REGULAR MEETING MINUTES

Date: 4/20/2020
Time: 7:00 p.m.
GoToWebinar.com – ID #228-837-467

- G1. Study Session/Andrew Morcos/165 Jefferson Drive: Request for a study session review for a future application for a use permit, architectural control, environmental review, and BMR agreement. The proposal includes demolition of an existing 24,300- square-foot office building and redevelopment of the site with approximately 158 multi-family dwelling units and a 14,422-square-foot commercial space with an above grade, three-story parking garage integrated into the proposed eight-story building, located in the R-MU-B (Residential Mixed Use, Bonus) zoning district. The proposal includes a request for an increase in height, density and floor area ratio (FAR) under the bonus level development allowance in exchange for community amenities. The proposal would also utilize the density bonus provisions in the BMR Housing Program, which allows density and FAR bonuses, and exceptions to the City's Zoning Ordinance requirements when BMR units are incorporated into the project. ([Staff Report #20-023-PC](#))

MULTIFAMILY HOUSING PROJECT
165 JEFFERSON STREET,
MENLO PARK, CA
SUBMITTAL FOR STUDY SESSION

GREYSTAR | HM | BKF 100 | HKS | MENLO FLATS | 145 JEFFERSON DRIVE, MENLO PARK, CA | 12.18.2019 | VIEW | A-004d

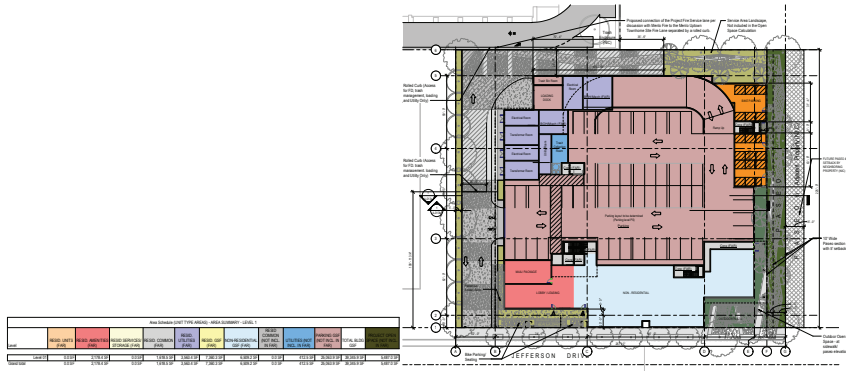
Commissioner DeCardy asked if the 21 BMR units would be at the moderate income level. Mr. Morcos said those were at the low income level per the BMR requirements. Commissioner DeCardy referred to sheet A004D and said the view of the paseo with the adjoining property showed quite a drop-off. Ms. Krolewski said a guardrail would be needed on that edge about 42-inches high, somewhat transparent, perhaps a cable rail. She said in time that would probably be removed as other sites were raised. She said on that west side they also had a planting buffer about five feet wide with trees that would help break up that grade change.
